| Title of Change: | Alignment of Case Outline 457-04 Symbol Drawing with JEDEC Standards |
| Change Sub-Category(s): | Align the document of physical dimension case out line 457-04 with JEDEC standards |

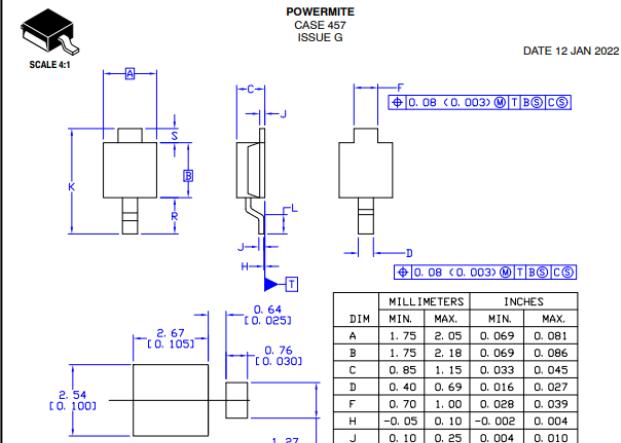
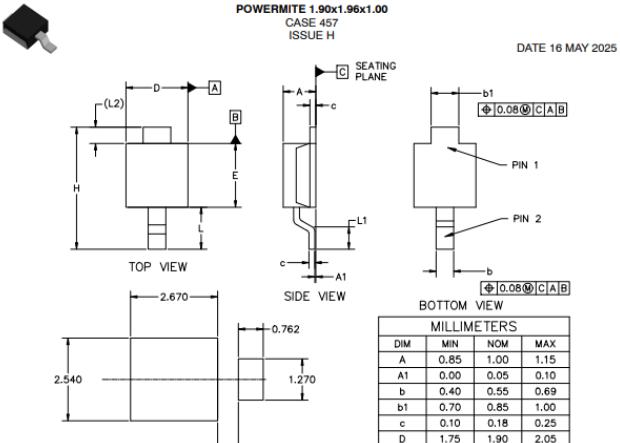
The symbol drawing will be changed from version G to version H to align with the JEDEC standard.

| POD CASE 457 | | | | |
|----------------|-------------|----------------|-------------|-----------------|
| H | -0.05-0.10 | a1 | 0 – 0.10 | Standardization |
